WORKSHOP AGENDA

Planning Commission

July 14, 2026 @ 5:30 PM

Item #: 3. Site Plan - Zaxby's - New Restaurant on 0.74 Acres. Property located at 5175 Murfreesboro Road (Tax Map 15, Parcel 2.01). DD (Downtown District) Zoning District. Property owned by Guernsey Holdings ZRC OPCP, LLC. Requested by Carter Engineering.

SHEET NUMBER:
C-1.0

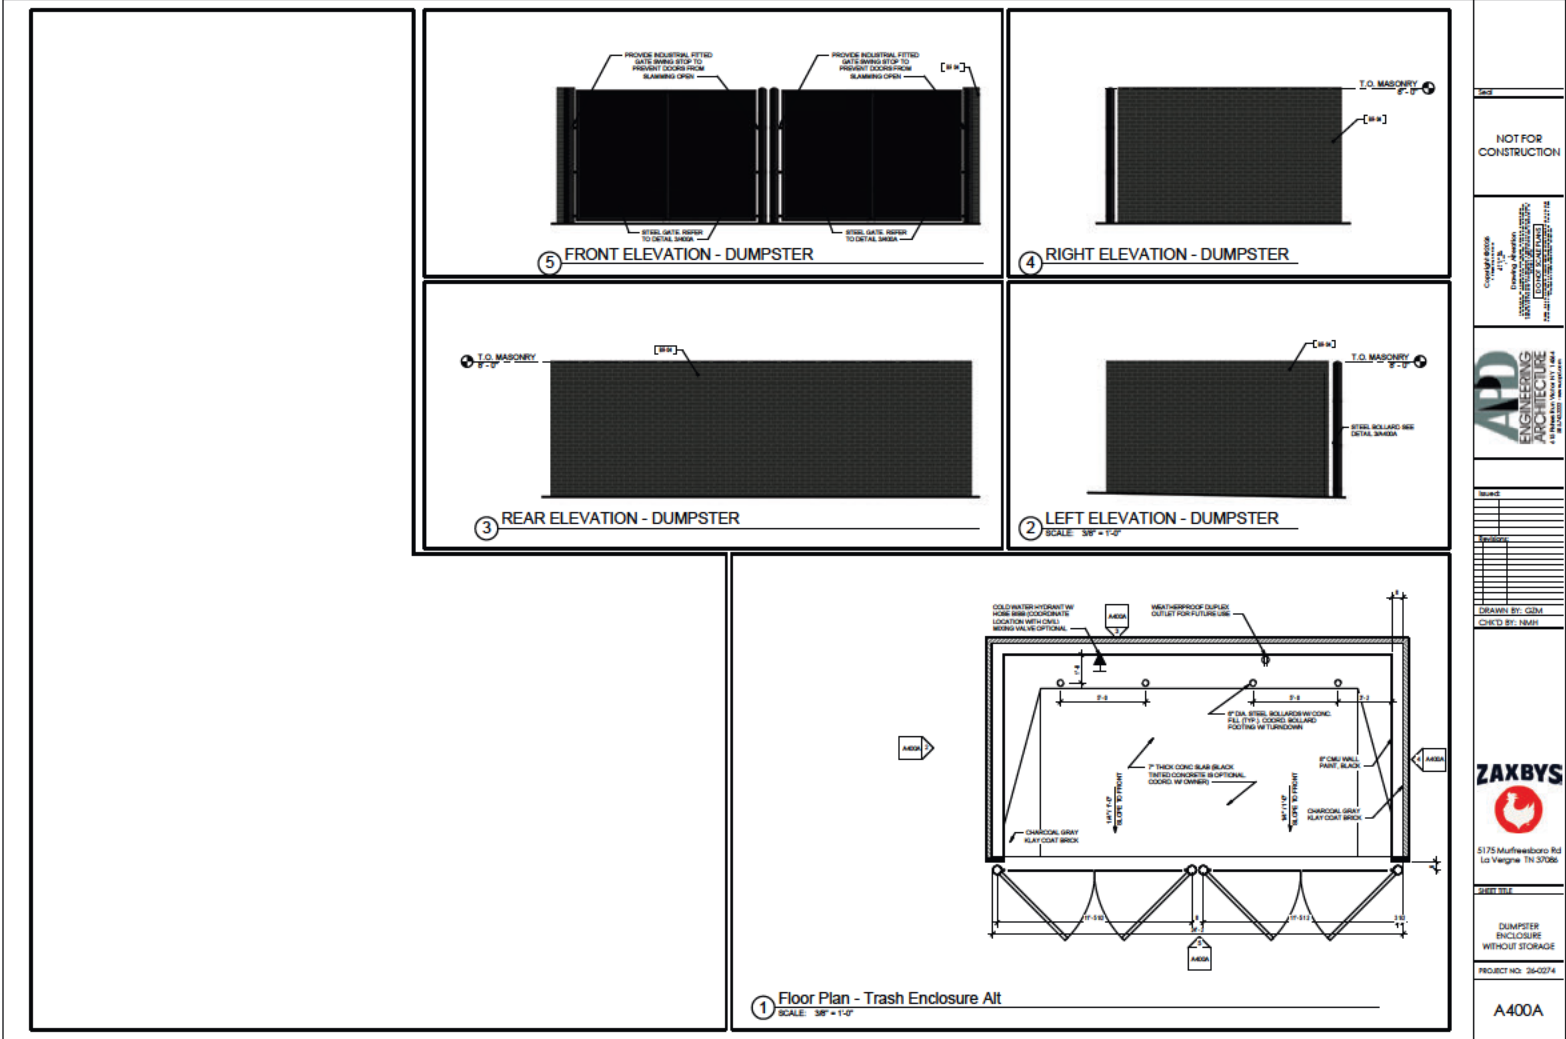
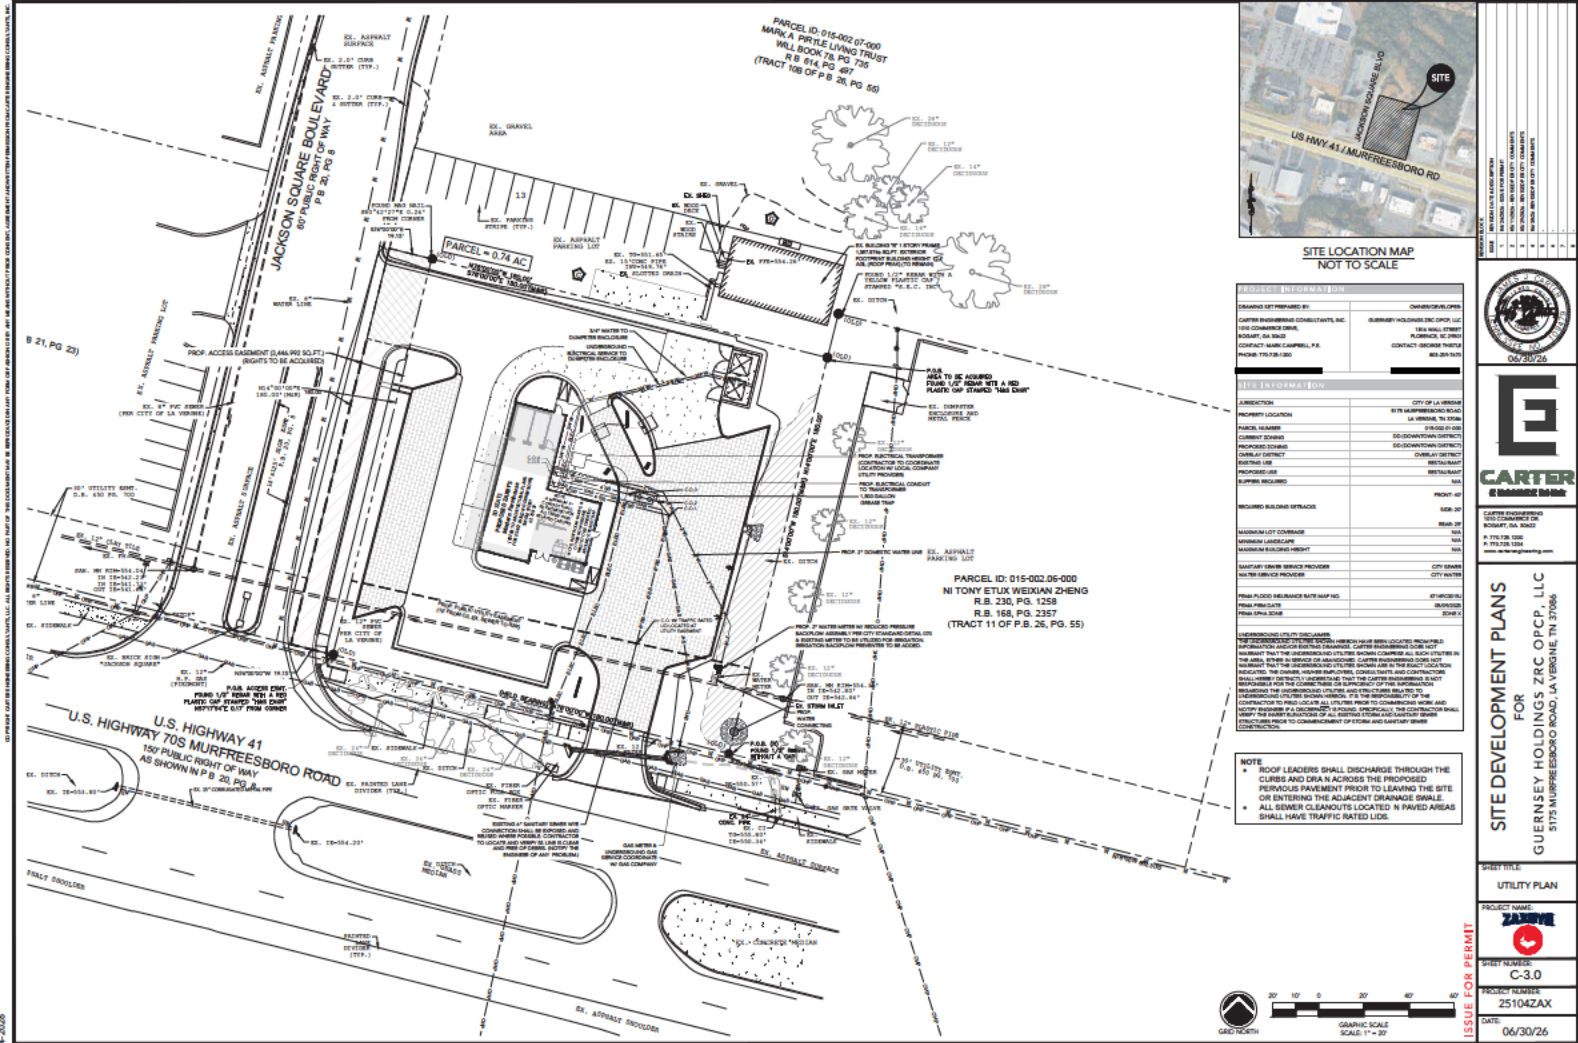
1. (Multiple sheets) Existing Building 'B' is shown on all plans as "To Remain". That building has already been demolished by others.
2. (Sheet C-4.0)) Provide calculations proving that the proposed 15" RCP drain pipe under the drive from Murfreesboro Road will be sufficient to pass the 25-year/24-hour storm. This is in addition to any TDOT requirements.
3. (Sheet C-2.0) Please provide an agreement with the property owner of the 19.15' strip of land along Jackson Square Blvd confirming that access and construction will be allowed in and through this property.

A200

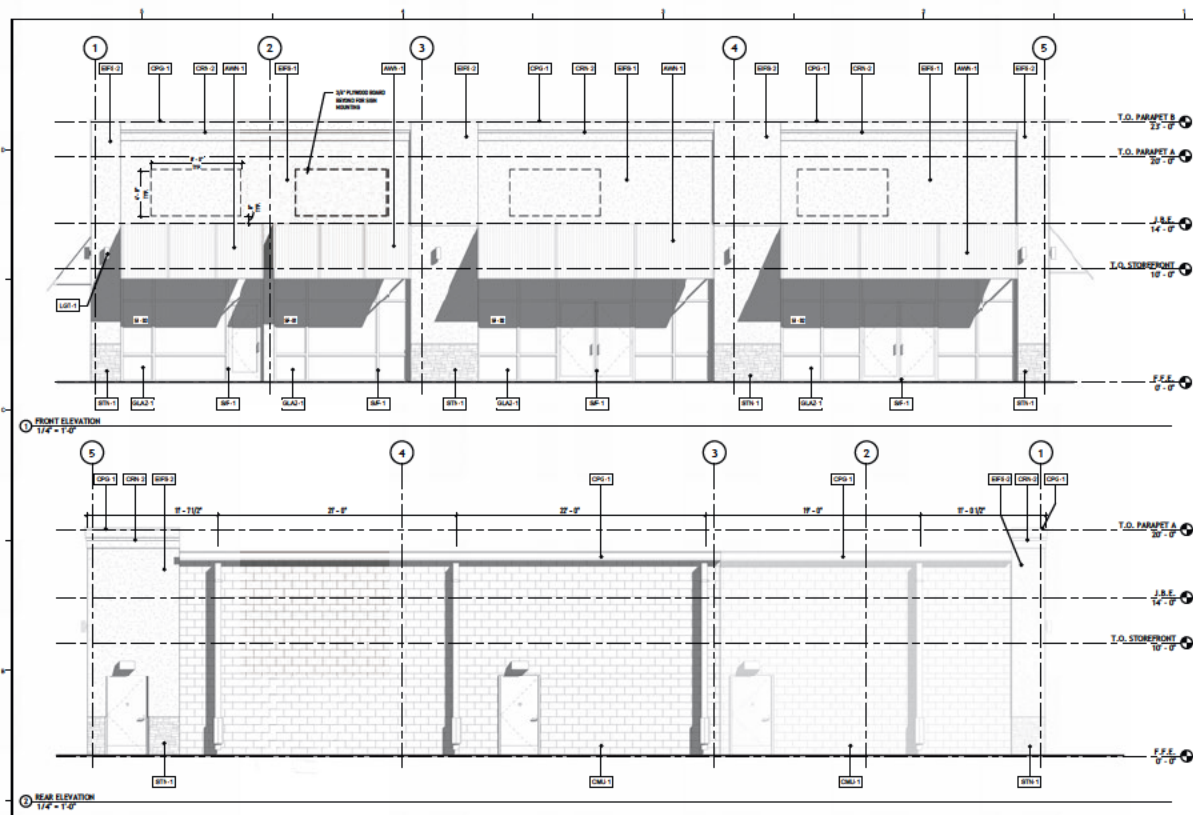
1. Architectural elevations received Friday, July 10 - 100% EIFS has been removed and elevations now show brick - Staff is still reviewing percentages to see if they meet City regulations.
2. The required materials board was not submitted. Only random samples were sent to City. The material board must contain actual samples of all exterior materials;
3. There is a property boundary callout dispute because final plat and survey do not agree;
4. Any work done along the entirety of the western boundary requires approval from the Industrial Development Board because the roadway and sidewalk are being shown on the industrial development board property.
